DOCKETED	
Docket Number:	23-AFC-01
Project Title:	Morton Bay Geothermal Project (MBGP)
TN #:	260729
Document Title:	Staff Response to Committee Orders
Description:	Staff Response to Request for Information Regarding Cultural and Tribal Cultural Resources
Filer:	susan fleming
Organization:	California Energy Commission
Submitter Role:	Commission Staff
Submission Date:	12/18/2024 5:00:50 PM
Docketed Date:	12/18/2024

Morton Bay Geothermal Project

Staff's Response to: REQUEST FOR INFORMATION REGARDING CULTURAL AND TRIBAL CULTURAL RESOURCES

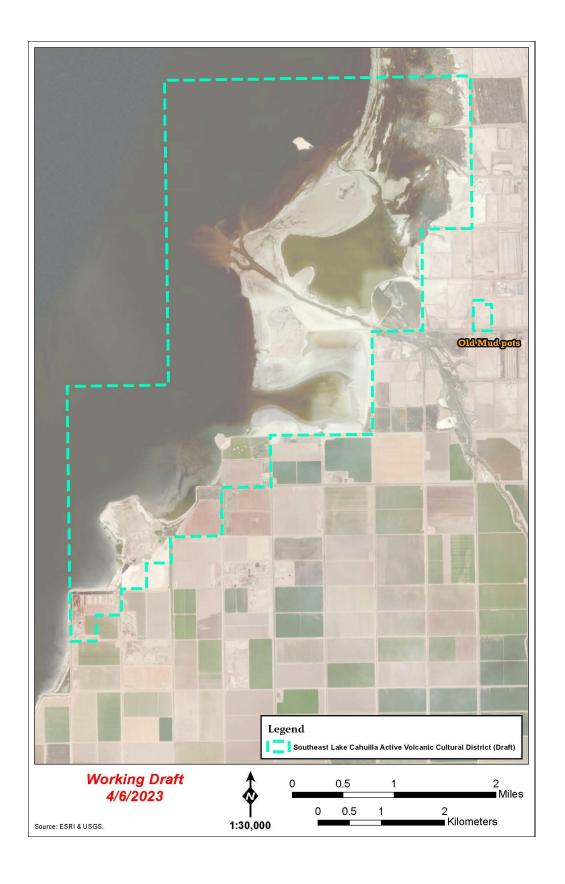
Analysis of the evidence supporting the boundaries of the Cultural District as currently proposed. Nothing herein is directing the filing or public disclosure of confidential information. Confidential information may be discussed in general terms as appropriate. Additionally, to the extent necessary to support the proposed boundaries, Staff shall, and the other Parties may to the extent known to them, cite material filed in the dockets of the proceedings designated as confidential without publicly disclosing the information.

Again, the full evaluation and expression of the results of staff's analysis is appropriately included in the FSA, and these preliminary remarks are subject to change. Based on current data, the Cultural District consists of two discontiguous units (Figure 5.4-2), units A and B. The former contains the five volcanic domes of Obsidian Butte, Rock Hill, Red Island, and Mullet Island; two areas of Mud Volcanoes and Mud Pots (CA-IMP-003256H and The New Mud Pots and Volcanoes); a Pond of Good Water (CA-IMP-3251H); and the Saltwater Pond (CA-IMP-003255). Unit B contains the Mud Volcanoes and Old Mud Pots (CA-IMP-003257H). (TN 257697, page 5.4-50; see figure below.)

The Cultural District incorporates the main cultural features of the Salton Buttes: Obsidian Butte, Rock Hill, Red Hill, Mullet Island, the sets of mud pots, as well as their physical and visual connectivity, and setting. The boundary shape is drawn from information presented to CEC cultural staff by tribal representatives during the consultation process. The Cultural District boundary roughly follows the Salton Sea Shallow Geothermal Anomaly, although it is depicted with a smaller footprint. Because the water line for the Salton Sea is not static, the delineation of boundary lines mostly corresponds with United States Geological Survey guadrangle map section and section subdivision lines, which is consistent with the Native American Heritage Commission practices for Sacred Lands File searches. The Salton Sea contributes to the district by creating a visual setting resembling Lake Cahuilla in pre-contact times. Future identification of additional contributing and character defining features and buffers from potential incompatible uses, as defined by the perspective of the living traditional community (local tribes), may result in adjustment of boundaries in the future. Given the dynamic nature of this landscape, boundaries also consider fluctuations in the water line of the sea. (TN 257697, page 5.4-53.)
